Value Engineering Study

East Side Coastal Resiliency Project

April 2018

Preliminary
Value Engineering Study Report
for

Alternative No.: LI-41

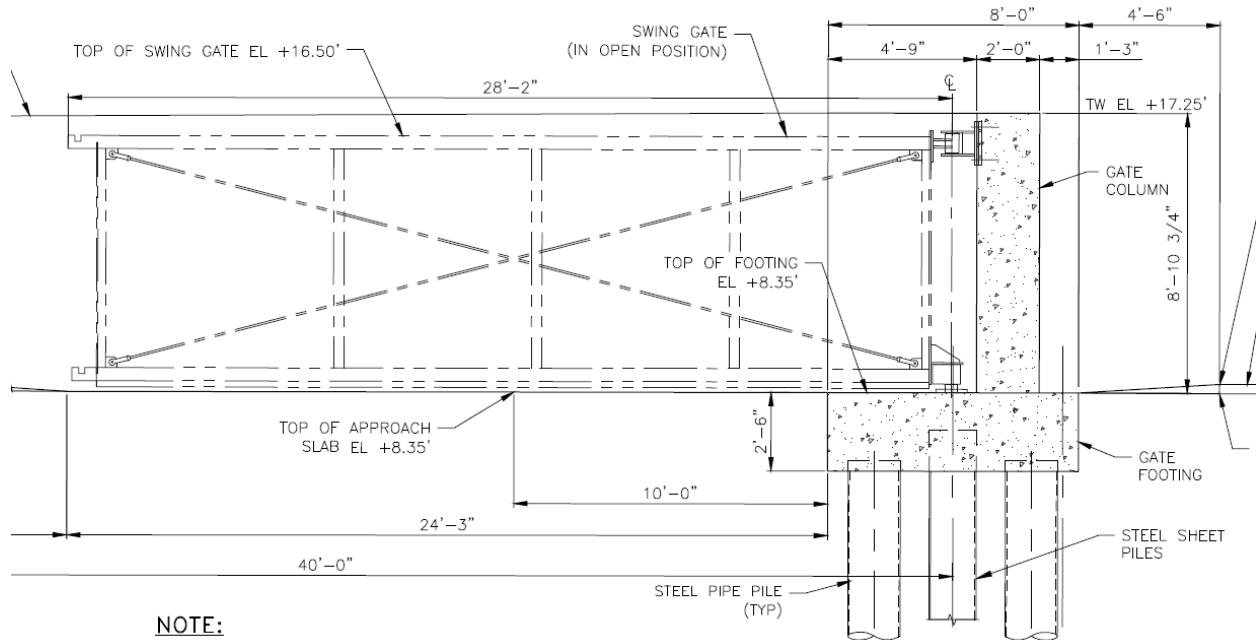
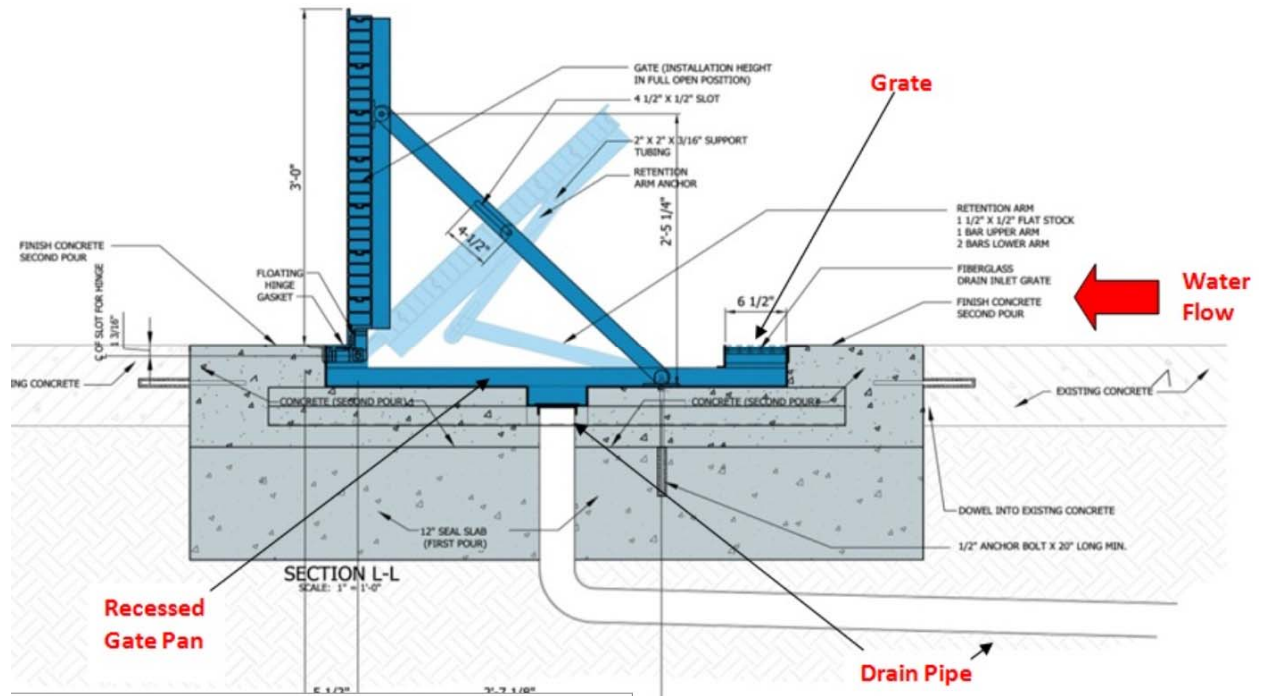
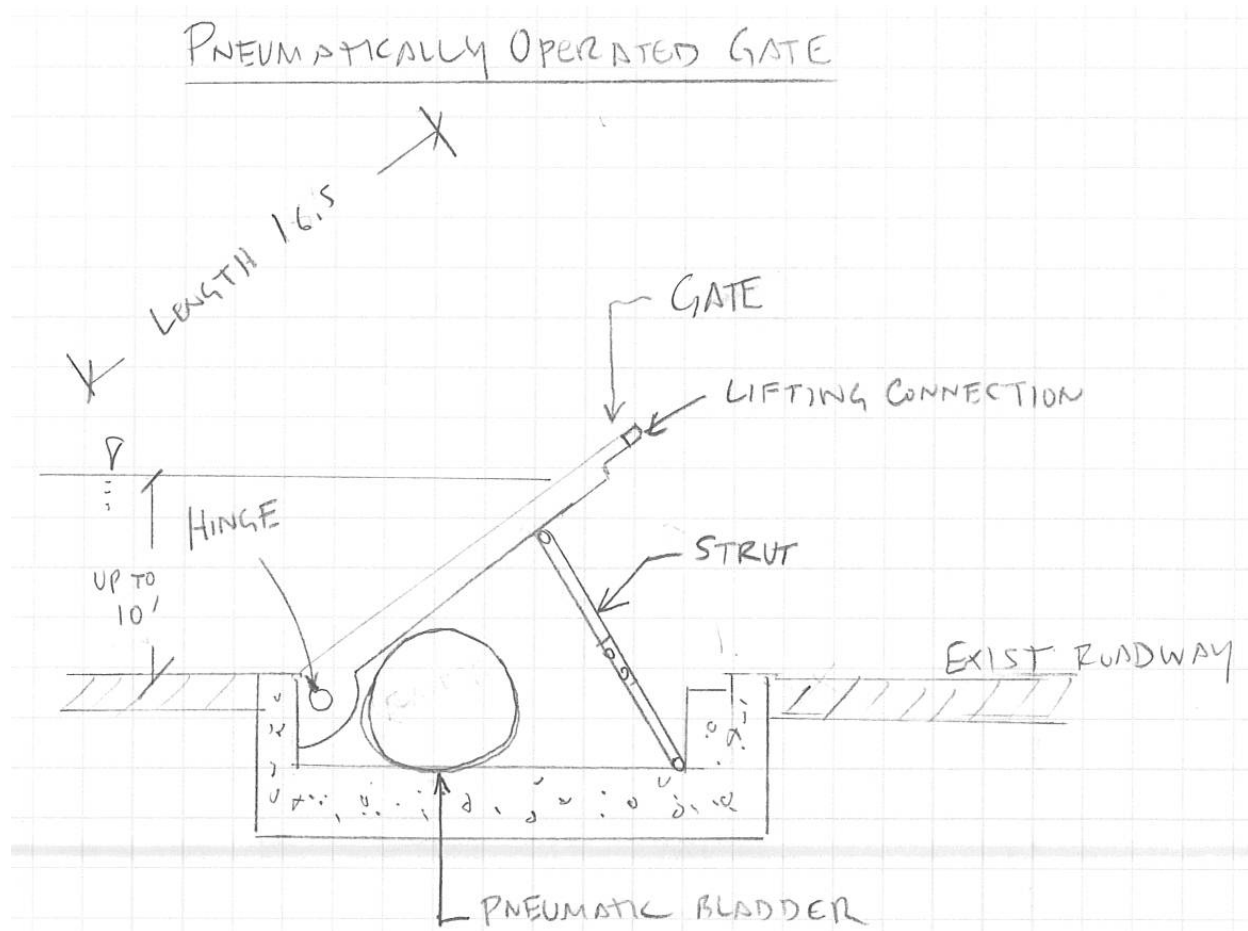
Quantifying the reduction of foundation requirements is a challenge at this point, but these gates will likely require a less robust foundation than the heavier roller and swing gates.

Specialized design will be required to provide redundant systems. Special care should be taken for any self-actuating gates to ensure public safety (traffic control in anticipation of actuation, etc.).
